Our ref: 64120 – 06 A

Planning Ref: 223083

Site Land South of Bridge Farm, Reading Road, Arborfield, Wokingham, RG2 9HT

Our comments are provided below for the list of comments the Lead Local Flood Authority has made towards Pre commencement Condition 35 (*in italic, bold*): PRP Responses in Blue

a) Drawing ref: 64120_SK101 Rev P3 titled "Rising Sewer Connection Amendments" produced by PRP Consulting Engineers & Surveyors dated 01/09/2026;

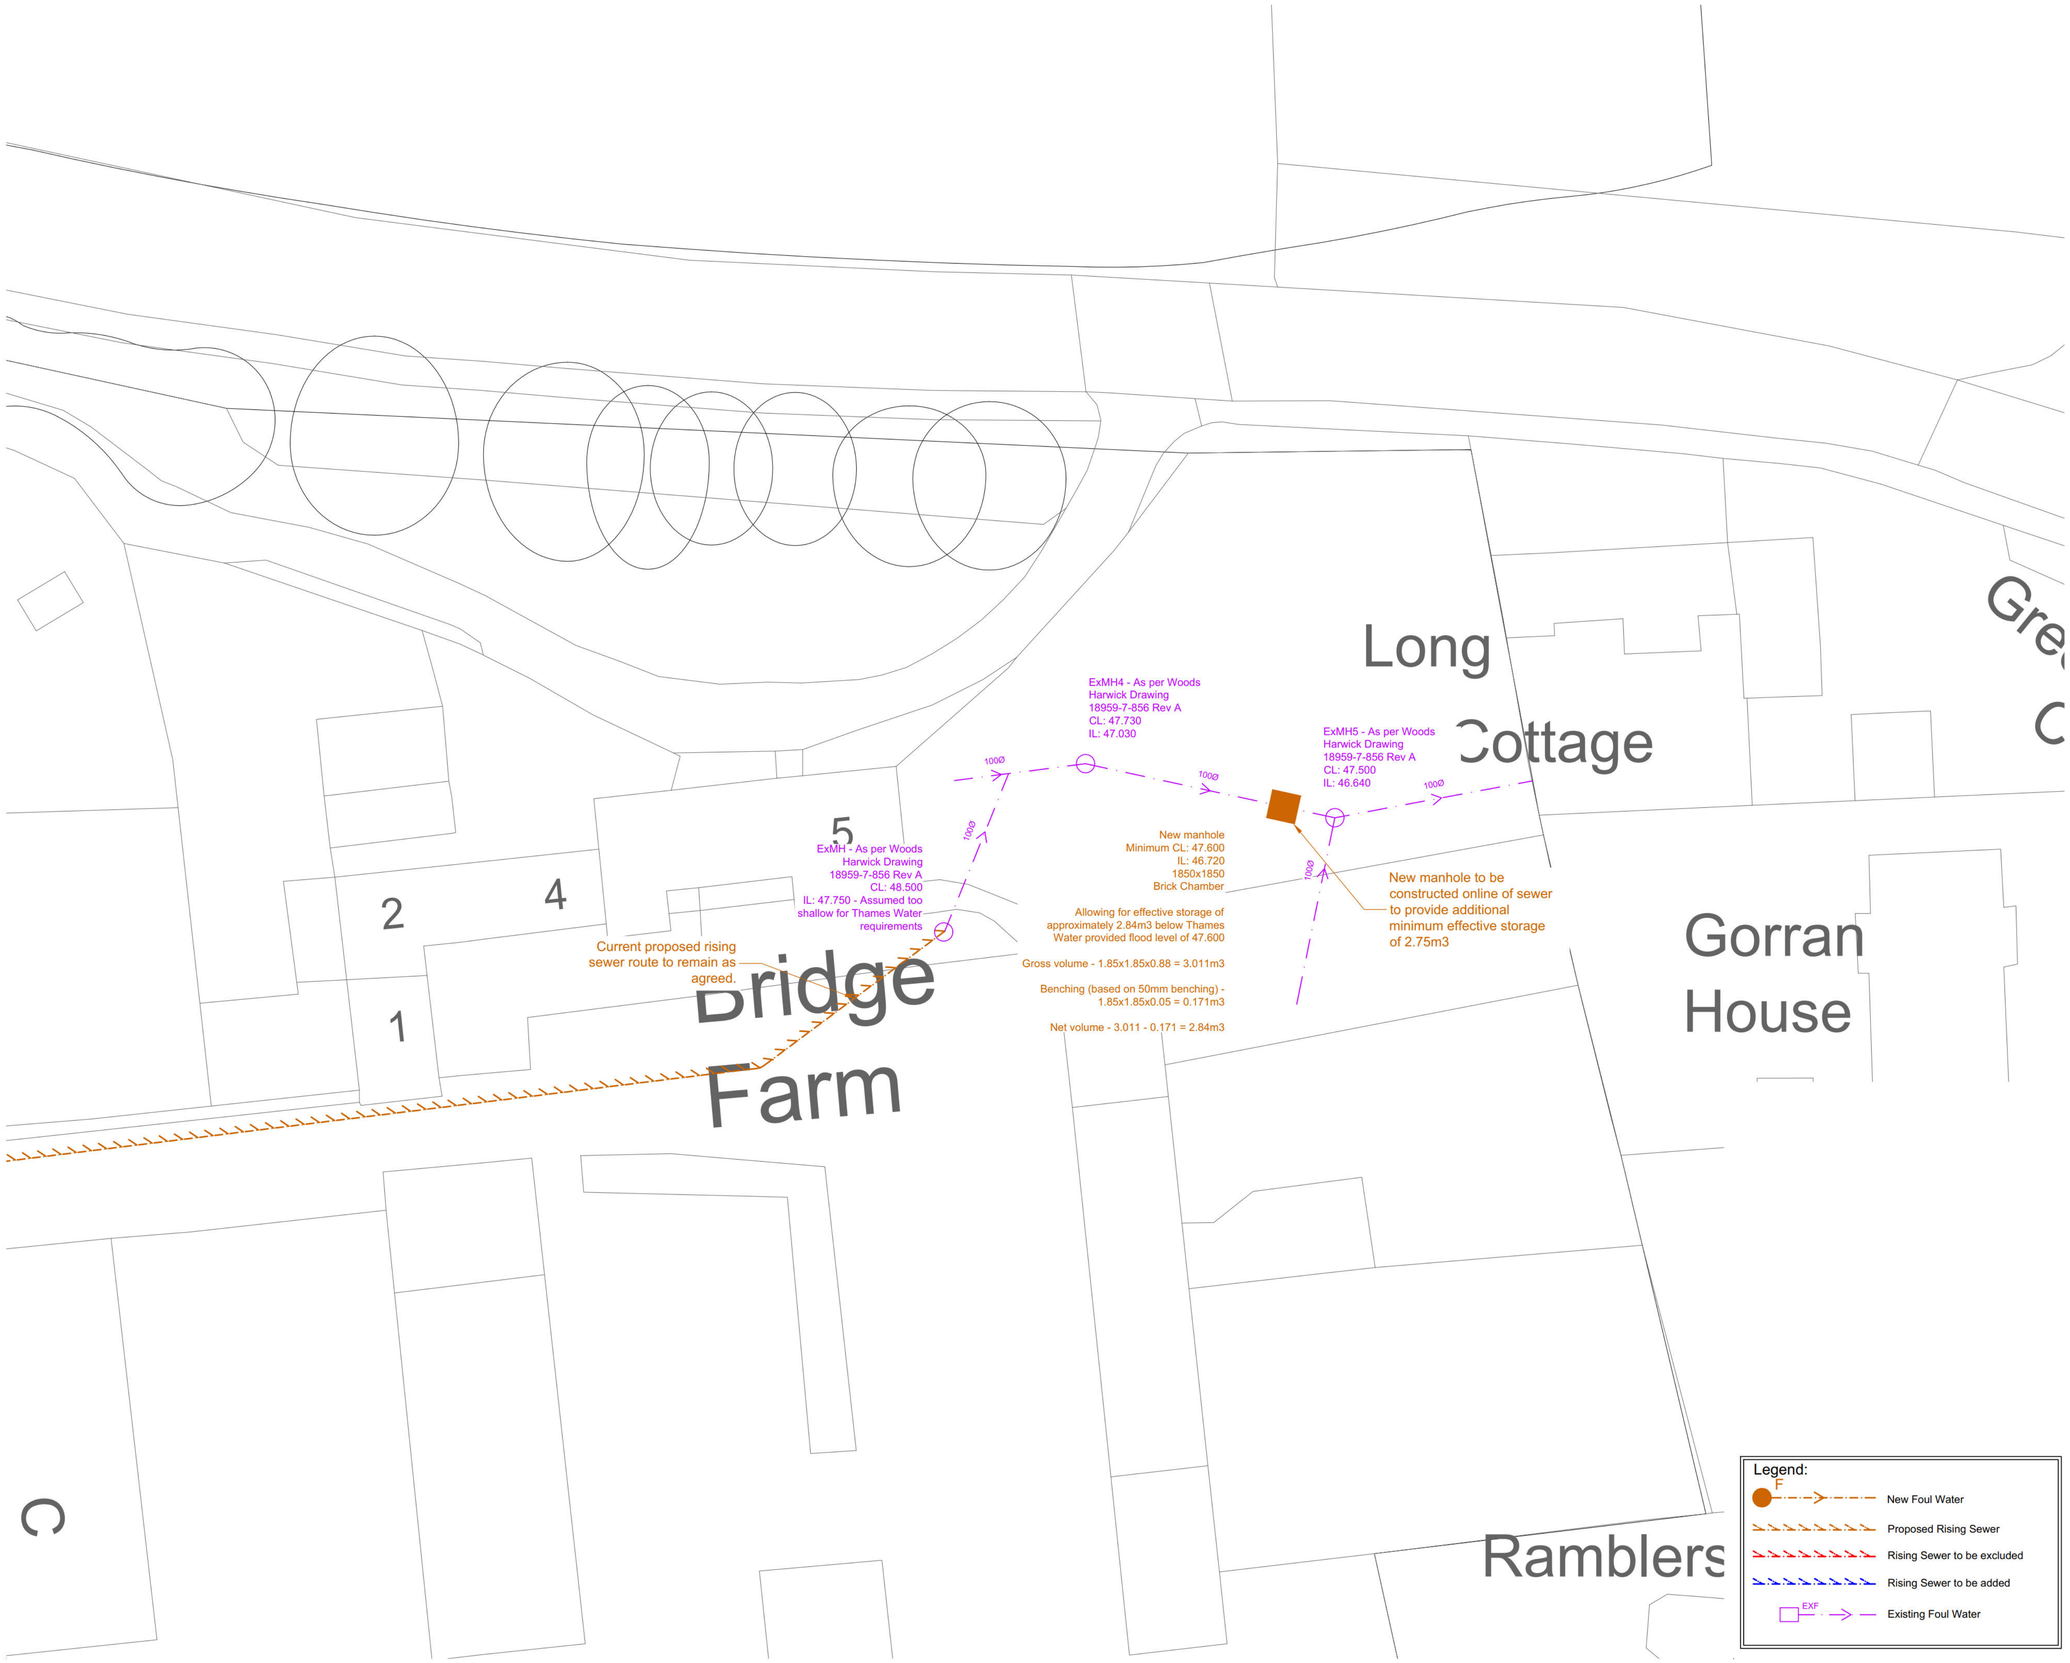
Thank you for sending across the design proposals. The only comment we have is, can you confirm the size of the sewer?

Following our call earlier, I have revisited this matter and attached a sketch drawing of our proposal for your review.

We propose to install a 1.85m x 1.85m x 0.88m deep brick chamber within the private foul drainage system on neighbouring land.

The chamber would be constructed directly on the existing drain run, which should simplify installation, minimise disruption to current users, and reduce the overall construction impact.

The proposed chamber would provide the additional storage currently absent from the system and, based on our calculations, should achieve more than the 2.75m^3 storage volume that you have advised is required at 2.84 m^3

The existing pipe is 100mm, I have amended the drawing (see this attached).

Rev	Date	Description	By / Chk
P3	01/09/2026	Existing pipe sizing shown	GF /
P2	27/08/2026	Issued for comments	GF /

I write to confirm that Thames Water have completed our review of the submissions listed below in relation to the proposed foul water capacity. Based on the information provided regarding the upgrade of the existing private foul drainage system (a 1.8m x 1.8m new chamber) to provide additional storage capacity, thereby accommodating the additional foul flows generated by the development whilst maintaining water levels below those identified within the network surrounding Thames Water pumping station. Thames Water are satisfied that the proposed discharge to a maximum of 2.75m³/day from the development is acceptable. Thames Water are therefore satisfied that no further foul drainage capacity mitigation is required in relation to the proposed connection and have no further comments on the foul water proposals.

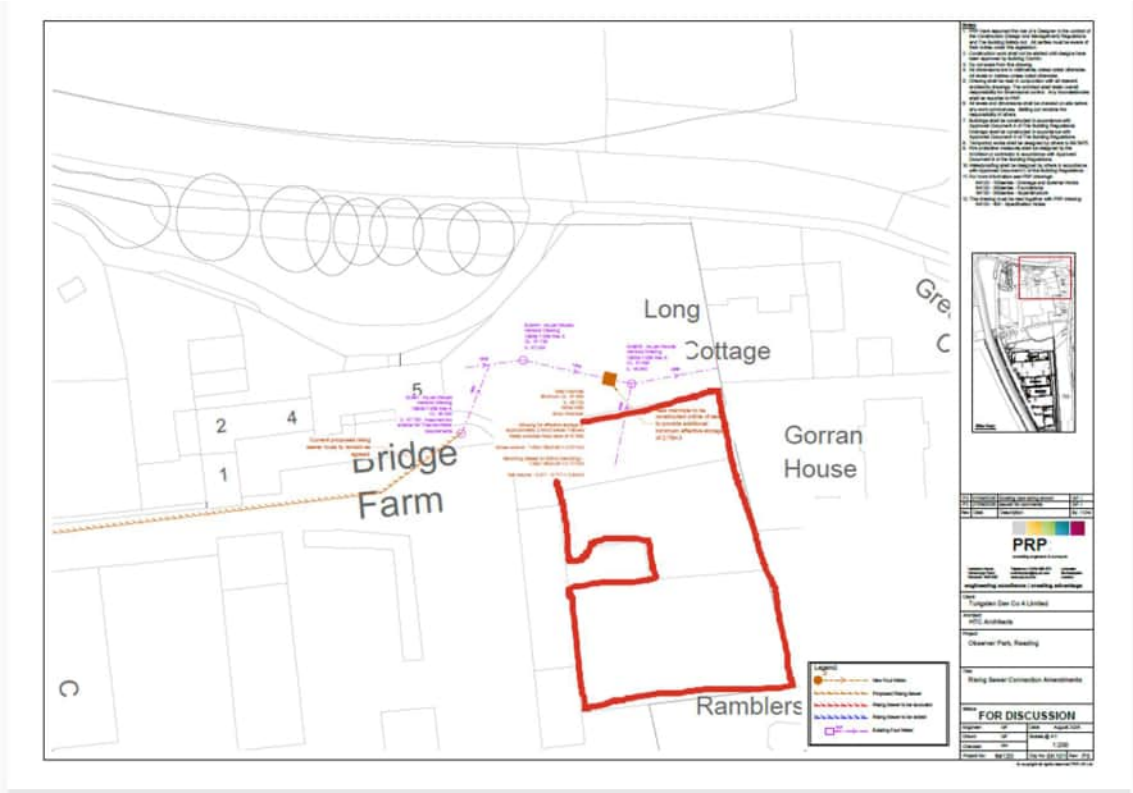
So sorry for the delay, here is the marked up version.

Looking at the plan, I believe the new manhole needs to be installed in the garden of Bridge Farmhouse, which is Tenanted and so would cause me a few issues. The land just below it, doesn’t have a purpose and I would be very happy for it be placed in there, with no issues at all. Please can you check whether this is possible?

Title:
Drainage Plan
Sheet 5

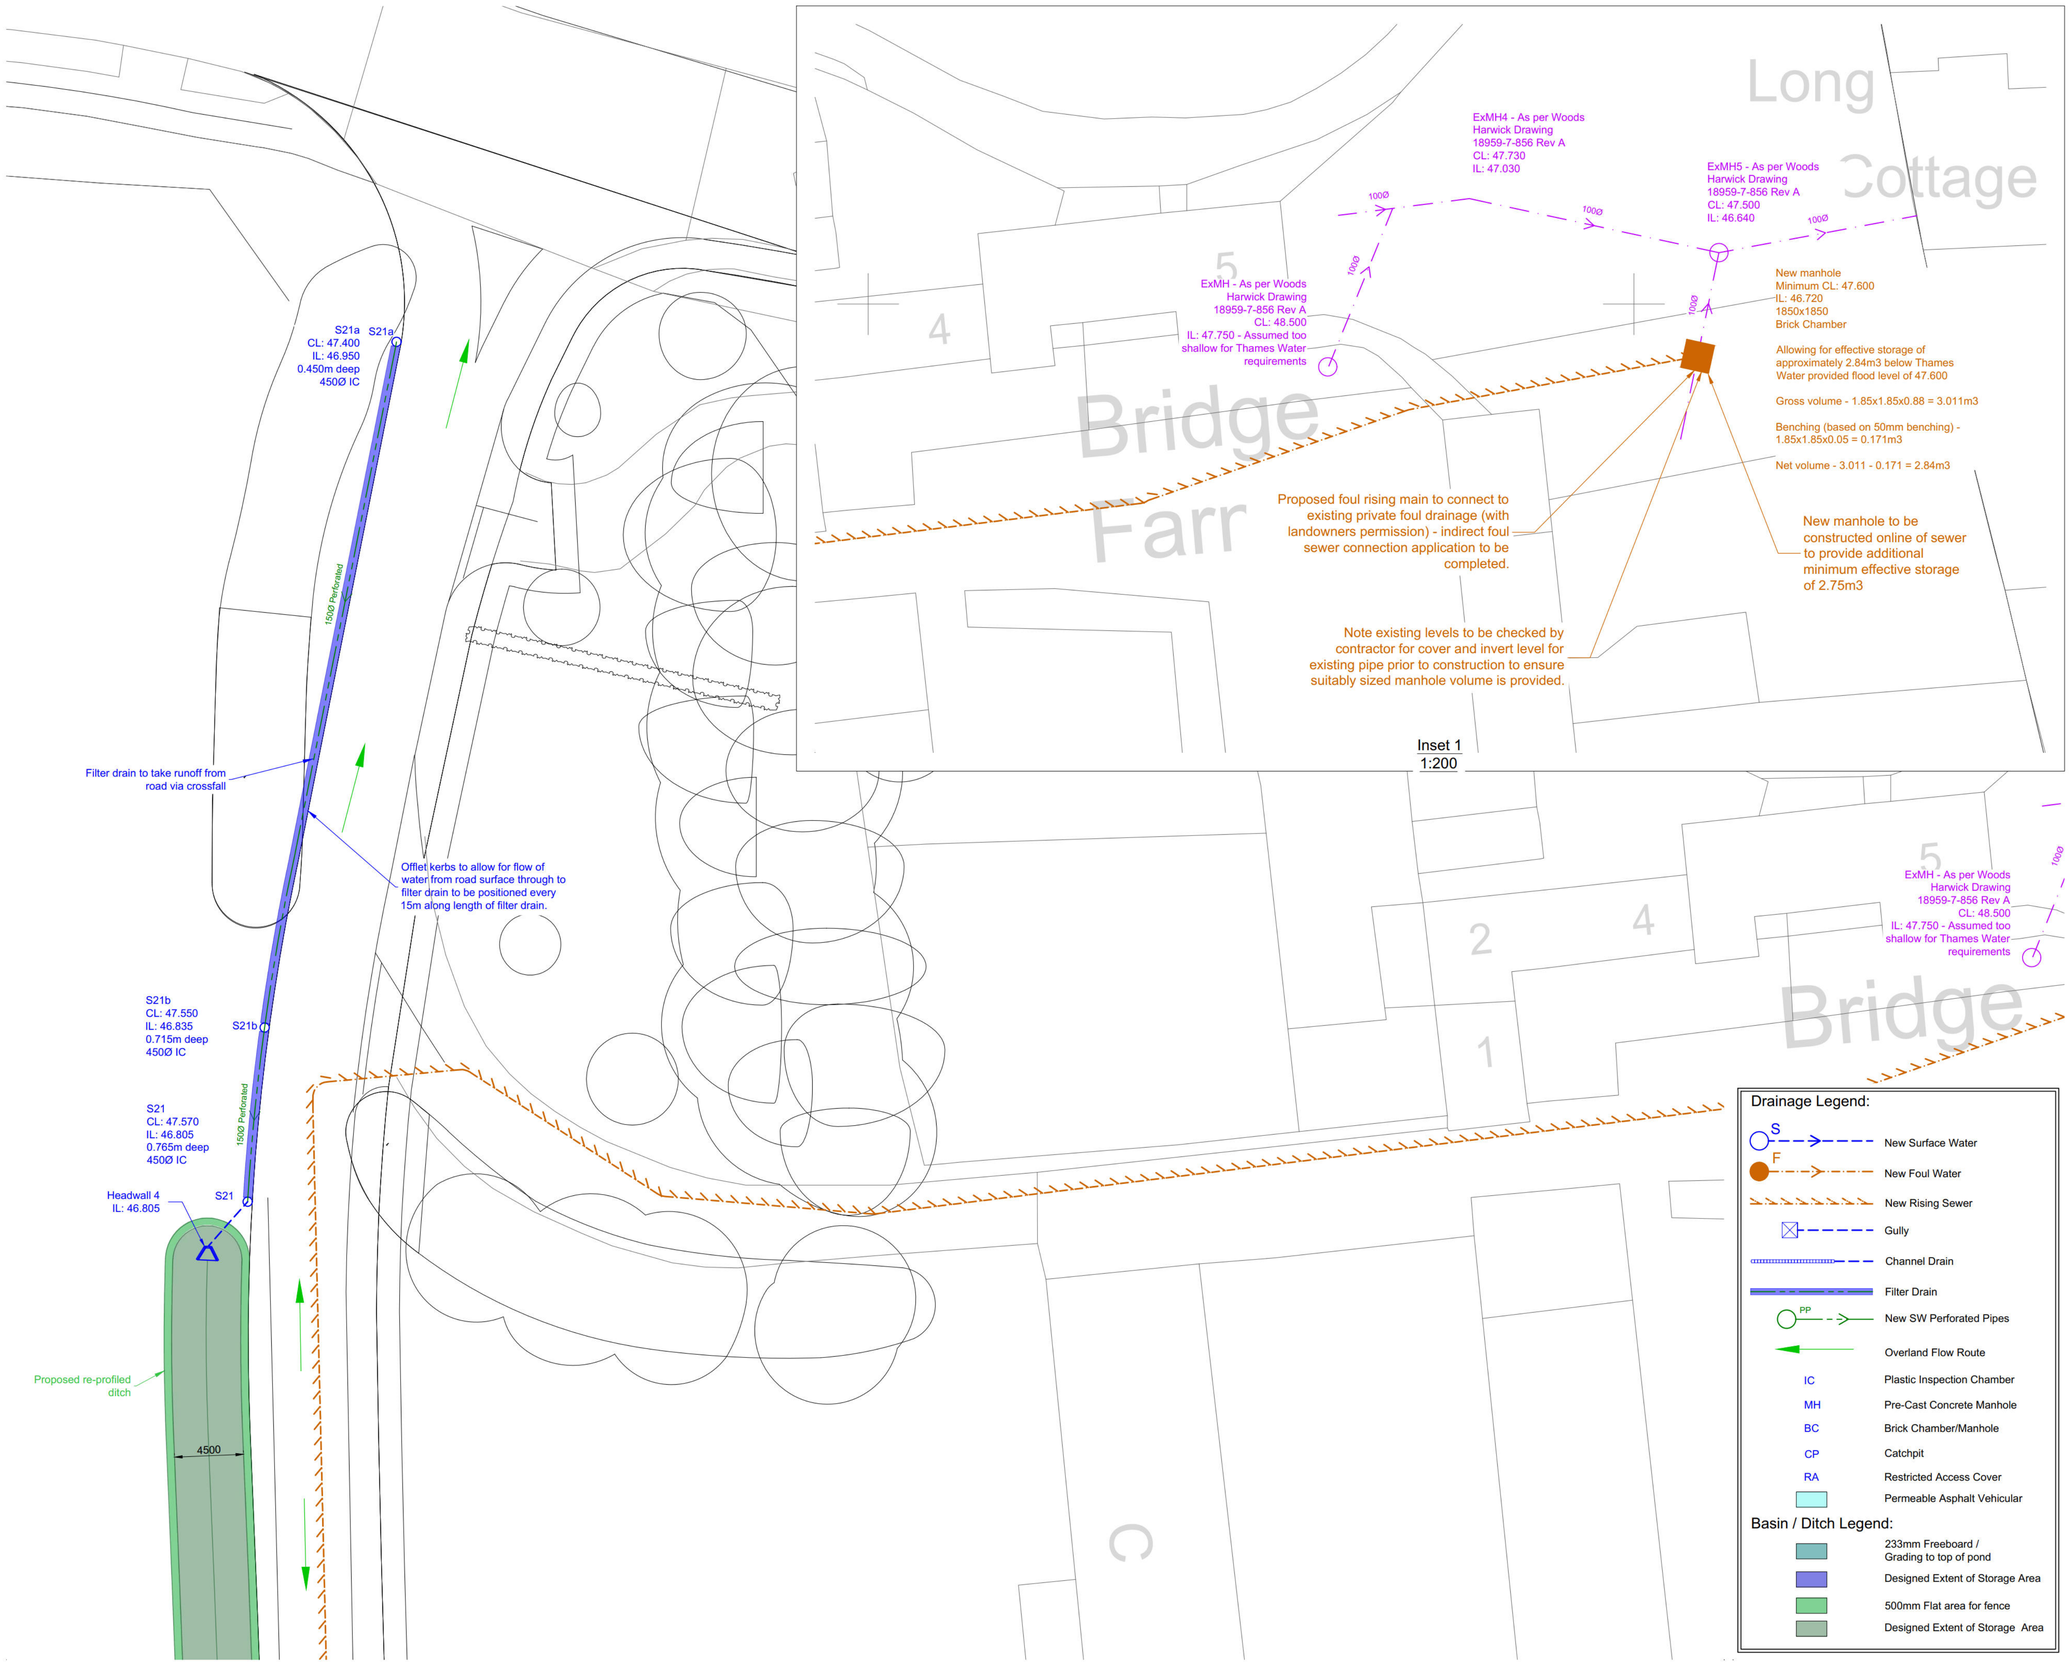
We have been discussing the proposed solution with both our client and the neighbouring landowner and are now close to reaching an agreement. Before progressing further, I would like to seek your acceptance in principle regarding the revised location of the proposed connection.

Due to the current tenancy arrangements on the land shown within the previous drawing issued to you, the landowner has asked whether the connection could instead be made within the parcel of land to the south, which is also within their ownership but is currently unoccupied. This would make the installation of the rising main and manhole significantly less intrusive.

At this stage, the proposed drainage solution and associated storage volume remain unchanged. However, as the design is currently based on interpolated survey levels, it will be necessary to verify cover and invert levels during the next stage of design. Should these levels not provide the required depth, we will revise the proposal accordingly and update you. Subject to this verification, we hope the attached arrangement is acceptable.

Following subsequent discussions with the affected landowner, a revised connection arrangement was developed, whilst maintaining the agreed storage capacity and operational performance requirements. Further correspondence with Thames Water confirms acceptance of the revised arrangement shown on drawing 64120-105-T3 Drainage Plan Sheet 5.

Rev	Date	Description	By / Chk
T3	02/10/2026	Drainage amended: Foul cesspool removed and Foul outfall layout amended	GF /
T2	07/07/2026	Draft removed	GF /
T1	28/05/2026	Issued for Tender	GF /
P1	27/04/2026	Issued for comments	GF / NH
